FEDERAL COMMUNICATIONS COMMISSION
445 12th Street, S.W.
WASHINGTON DC 20554

In re: K237FC, Dallas, TX
BMPFT-20160712ABR
Facility ID No. 150497

This refers to the above-captioned minor change application for K237FC.

Overlap attachment:

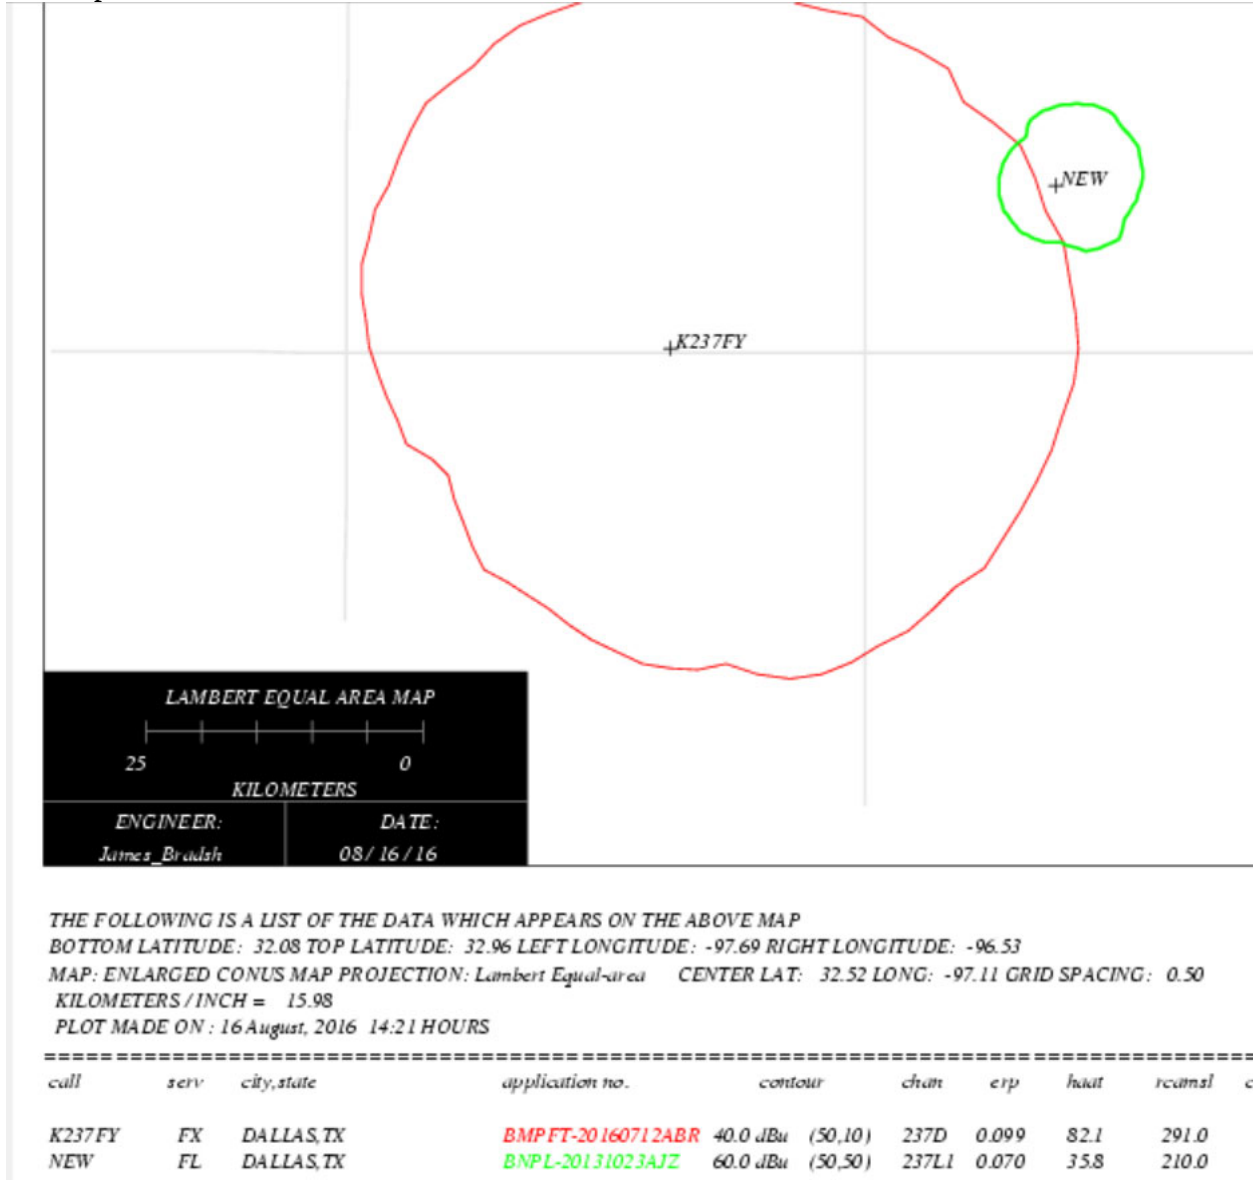
An engineering study reveals the application is in violation of the interference protection requirements of 47 C.F.R. Section 74.1204. Specifically, the proposed 40 dBu interfering contour overlaps the 60 dBu protected contour of the facilities of a co-channel LPFM construction permit for a KVWR-LP, Dallas, Texas (BNPL-20131023AJZ). The application does not recognize this defect. Accordingly, we dismiss the application as unacceptable for filing.

Red contour: K237FY, BMPFT-20160712ABR – 40 dBu interfering contour

Green contour: KVWR-LP, Dallas, TX BNPL-20131023AJZ – 60 dBu protected contour

In light of the above, application BMPFT-20160712ABR is unacceptable for filing pursuant to 47 C.F.R. § 73.3566(a) and IS HEREBY DISMISSED. This action is taken pursuant to 47 C.F.R. § 0.283.
